REMARKS

DETAILED ACTION

Drawings

FIG.2

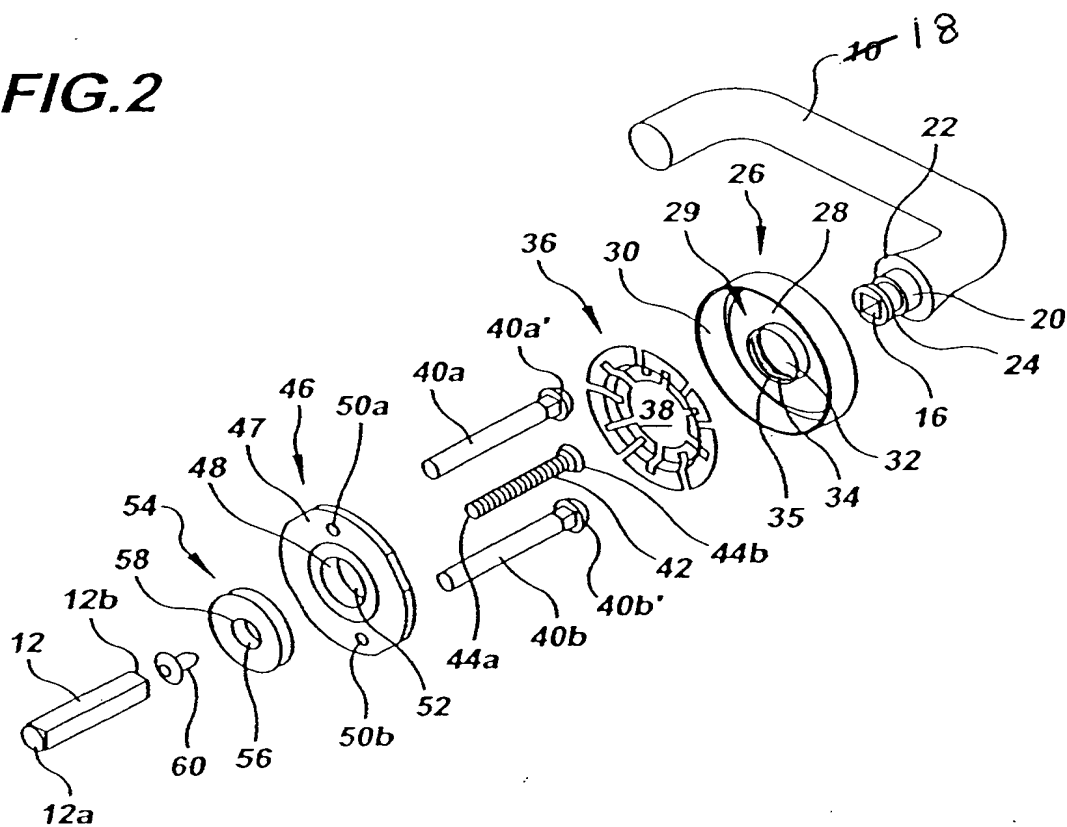
In Figure 2, change "10" to -- 18 --.

Referring to Fig. 2, Applicant shows the internal threads 35 in lip 34 of cover 26 and has corrected the numeral "10" handle to -- 18 -- .

FIG.3

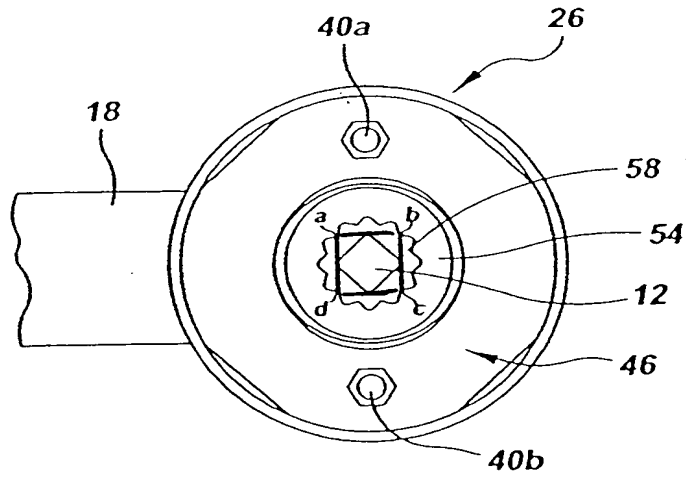
In Figure 3, clearly illustrates the spindle 12 (see attachment #1 point A).

In Fig. 3 the spindle 12 was corrected to show that it contacts points a, b, c, and d of star face 58.

FIG.4

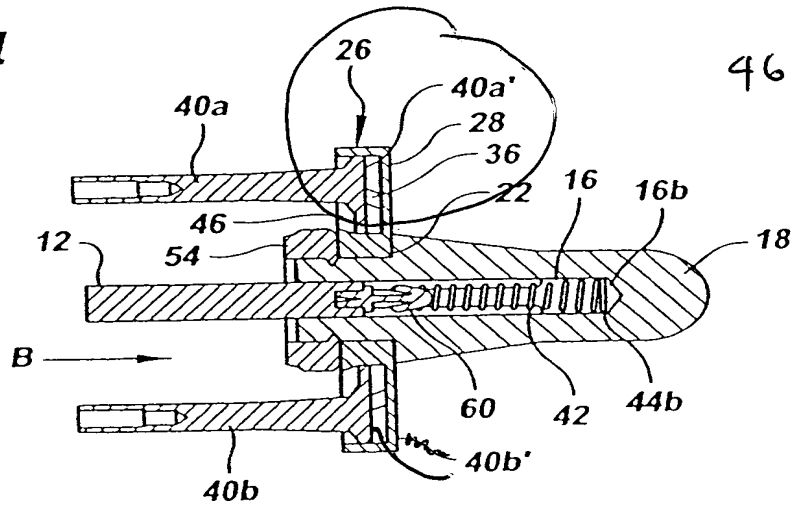
In Figures 4 and 5, clearly define the mounting plate and the mounting posts with appropriate cross-hatching. The current drawings show that the mounting posts and the mounting plate are a one-piece embodiment when they are separate members connected together (see attachment #1 point B).

In Figure 4, change the pointing line position of element 40b' (see attachment #1).

In Figure 5, change the pointing line position of element 48' (see attachment #1).

As seen in Figure 4, see attachment #2, the cover 26 has a lip 34 and the mounting plate 46 also has a lip 48. The lip 48 is located over the lip 34; therefore, the cover lip 34 has external threads that threadedly engage inner threads at the mounting lip 48.

In Figs. 4 and 5 amendments were made to conform the figures to the specification. Thus, cover 26 is shown having the lip 34 with internal threads 35. The mounting plate 46 is shown having lip 48 with external threads 49. The external threads 49 of mounting plate 46 are screwed into threads 35 of lip 34 of cover 26.

Also, in Figs. 4 and 5 the lead line for 40b' was moved to the head of mounting pin 40b. Also, numeral 60c was added to show the end of anchor 60 which is inserted into the opening in spindle 12. Internal threads are shown in cap nut 54 and external threads 24 are shown at the end of handle 18.
